RENESAS TECHNICAL UPDATE

Product Category	MPU & MCU	Document No.	TN-RX*-A066A/E	Rev.	1.00
Title	Errata to RX62T and RX62G Groups User's Manuals Regarding CAN Module		Information Category	Technical Notification	
Applicable Product	RX62T Group	Lot No.	Reference Document	RX62T Group User's Manual: Hardware Rev.1.30 (R01UH0034EJ0130) RX62G Group User's Manual: Hardware Rev.1.00 (R01UH0321EJ0100)	
	RX62G Group	All

This document describes corrections to the chapter "CAN module" in the User's Manuals: Hardware of the above groups.

Figure 25.9 Transition between CAN Operating Modes

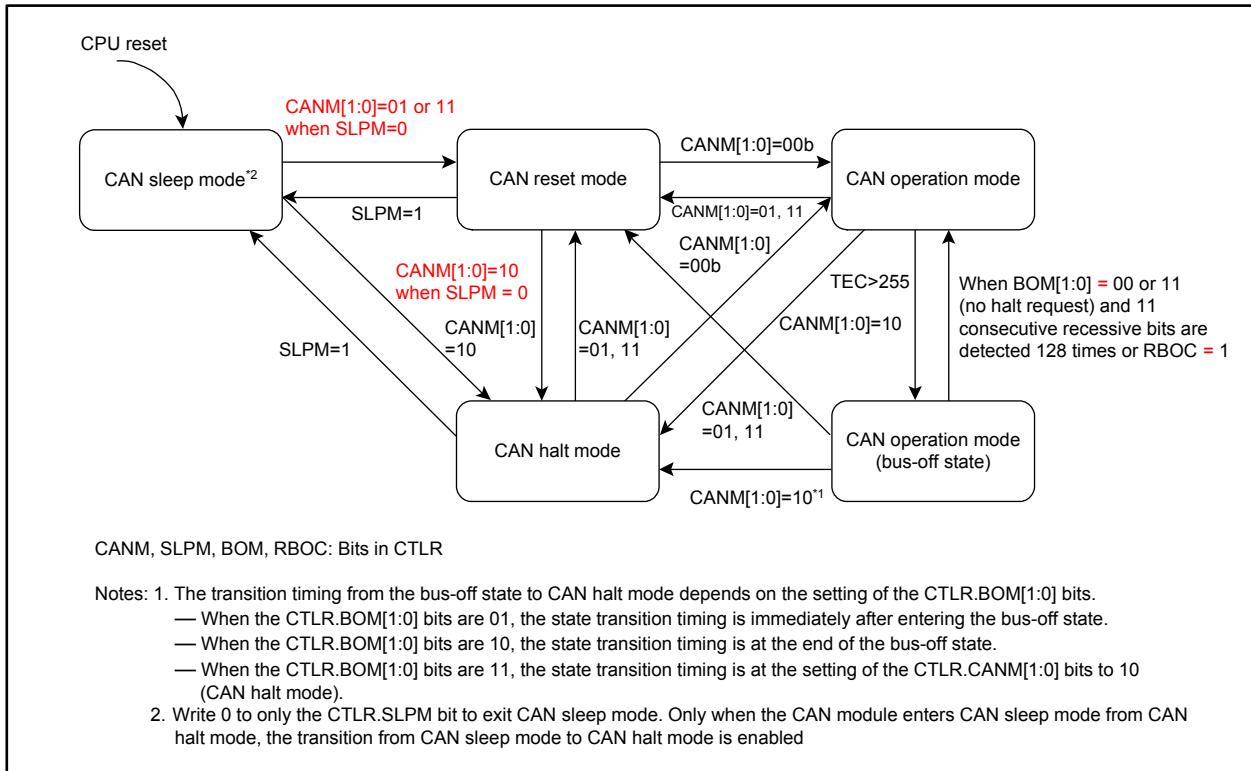
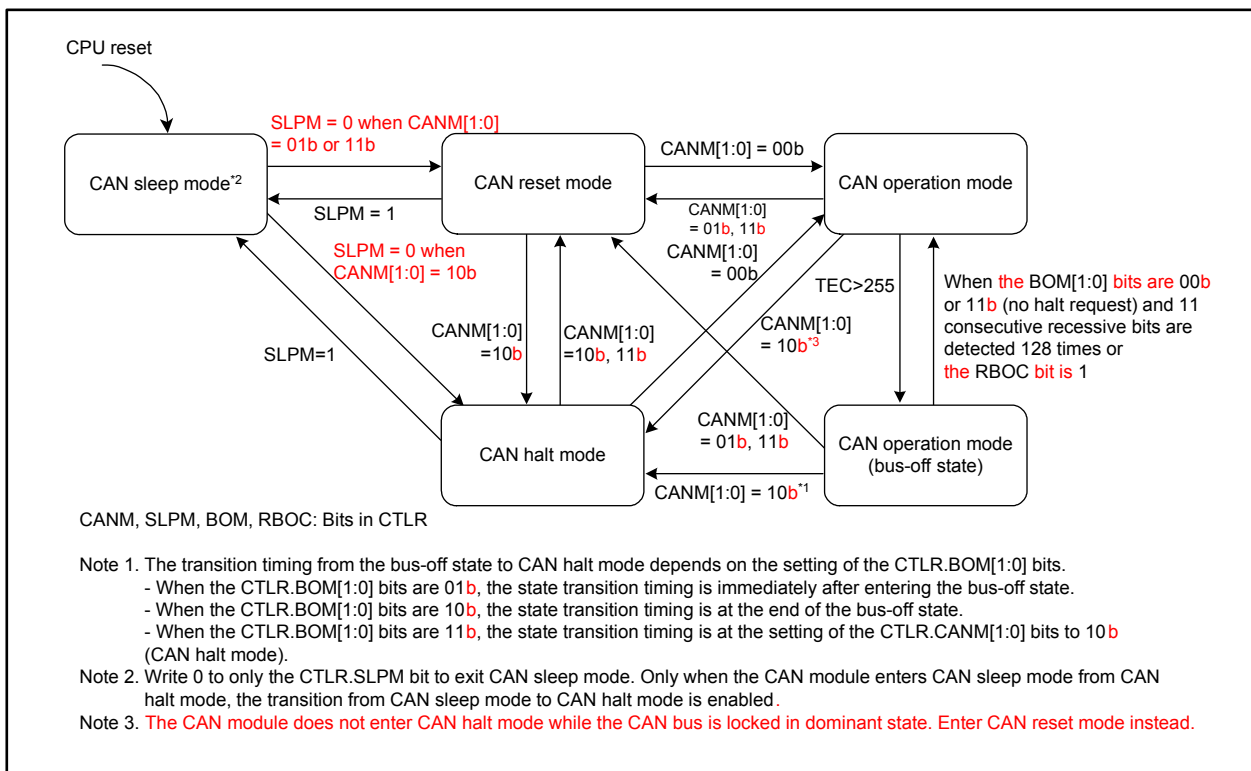
•Page 1081 of 1446
 Figure 25.9 is corrected as follows:
